**AERONAUTICAL CHARTING MEETING**  
**Charting Group**  
**Meeting 22-02 – October 25 - 27, 2022**

**RECOMMENDATION DOCUMENT**

**FAA Control #22-02-376**

**Subject:** Distinction to be made for permanently unlit towers on VFR Sectional Charts to enhance pilot awareness.

FAA Chart Users' Guide - VFR Terms and Symbols

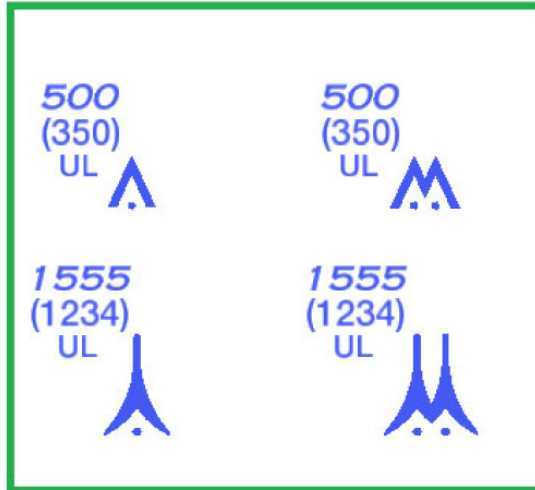
Pilots, particularly flying under VFR, are expecting to see obstacles, which are lit on sectional charts. An unlit obstruction greater than 200 FT AGL in the NAS may be a potential Hazard to VFR Navigation if pilots are not made properly aware.

In addition, there are a number of NOTAMS in the FAA system of permanently unlit obstacles. A distinct annotation of an unlit obstacle on a sectional chart would reduce the number of NOTAMS required to be maintained for these obstacles.

This submission is to propose a distinction be made on VFR sectional charts to annotate which obstacles are permanently unlit.

We recommend the following distinction made in the charting annotation to denote which towers are permanently unlit by adding a “UL” symbology next to/below the MSL and AGL height to indicate permanently unlit.

UL Symbol using  
original size of .06
